MADDEN-COCHRAN SUBDIVISION, **RESUBDIVISION OF LOT 1**

APPLICATION NUMBER 4 DATE October 16, 2014
APPLICANT Madden-Cochran Subdivision, Resubdivision of Lot 1
REQUEST Subdivision

DETAIL SITE PLAN

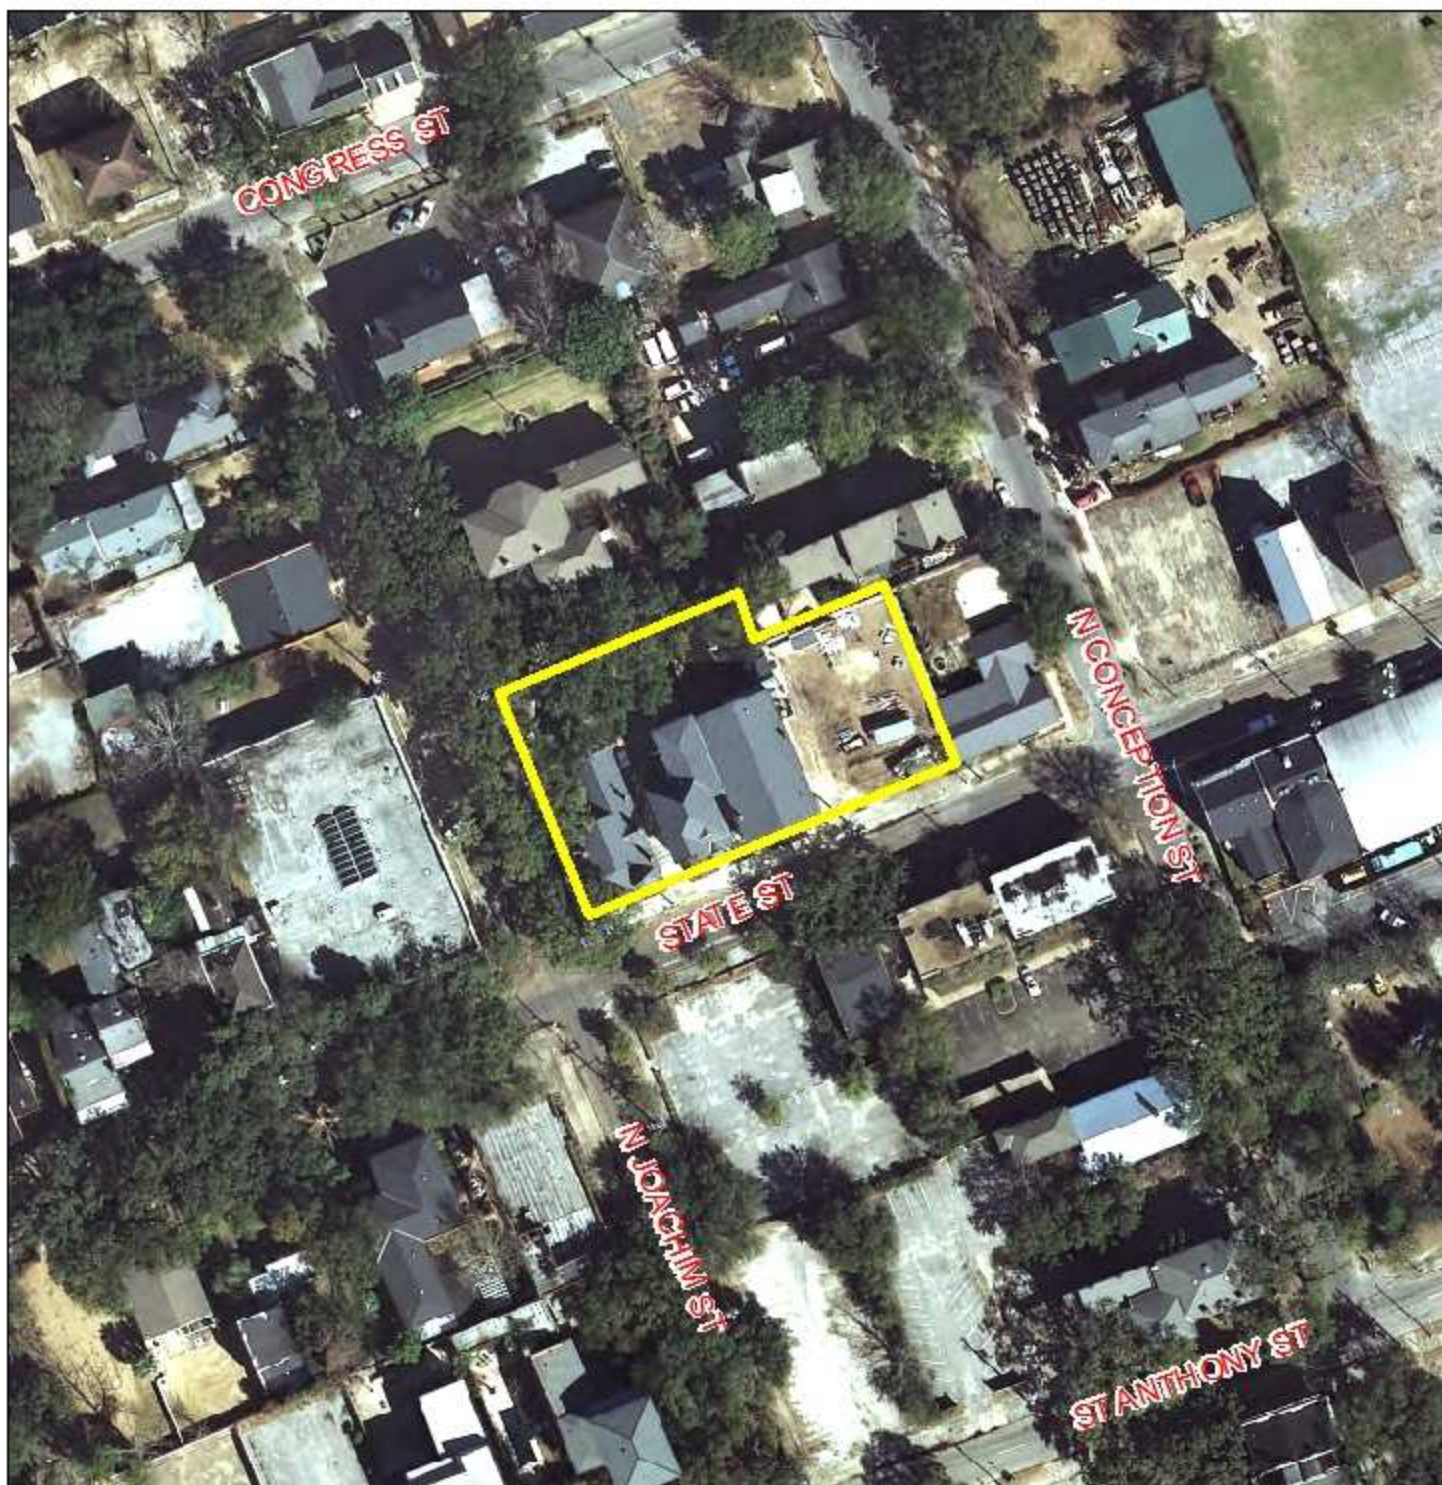
In lieu of the minimum lot size requirement, subdivided properties are limited to a minimum width of 18' and maximum width of 120' along a designated primary frontage. As proposed, the frontage along State Street for the proposed Lots A-D will range from a minimum of 43'± and a maximum of 65'±. Although the applicant did not specify a primary frontage for the proposed Lot A, as it is a corner lot, the proposed frontage of all 4 proposed lots appear to comply with Section 64-3.I.8.(b). of the Zoning Ordinance.

The site has frontage along 2 minor, "B Streets," with curb and gutter and a compliant 50' right-of-way and, as such, no dedication should be required. Given the street layout, character of the neighborhood, and location of the existing structure on the proposed Lot A, a waiver of the corner radius requirement of Sections V.B.16. and V.D.6. of the Subdivision Regulations may be appropriate at the intersection of State and North Joachim Streets.

The preliminary plat illustrates 2 easements on the site and, if approved, a note should be placed on the Final Plat stating that no structures can be placed or erected within any easement.

- 1) Illustration of all setbacks (or notes) on the Final Plat, in compliance with Section 64-3.I. of the Zoning Ordinance;
- 2) Placement of a note on the Final Plat stating: *(No structures can be placed or erected within any easement.);*
